City of Albuquerque

RE: REVISED DRAINAGE PLAN FOR AN ADDITION TO MARTIN J. VIGIL BUILDING
(J-14/D91) REVISION DATED MARC9, 1992

RE: DRAINAGE PLAN FOR AN ADDITION TO MARTIN J. VIGIL BUILDING. (J-14/D-91)
ENGINEER'S STAMP DATED JULY 31, 1990.

GRADING AND DRAINAGE PLAN NEW BUILDING ADDITION FOR

CONCRETE GUTTER DETAIL

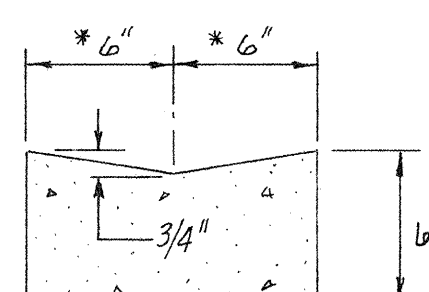
With regard to your letter of August 10, 1990, increasing the slope to 0.0050 ft./ft. will require the finish floor to be approximately 0.4' higher which the owner feels is unacceptably high. From elevations taken in the alley, it is evident that runoff from the site would not be conveyed by the alley to the closest public street. In discussion with Bernie Monyoya, it was agreed that a grade of 0.0020 ft./ft. would be acceptable on a project of this scale provided the owner holds the City of Albuquerque harmless in the event that construction results in "bird baths" or in the event that other damages result from the use of a substandard slope.

Therefore, the owner has agreed to sign the hold harmless statement below. If you have any questions or require additional information, please do not hesitate to contact me.

I, Martin J. Vigil, owner of property at 1315 Second Street N.W., hold the City of Albuquerque harmless for any and all damages that may be sustained by my property as a result of constructing the drainage swale at a substandard slope.
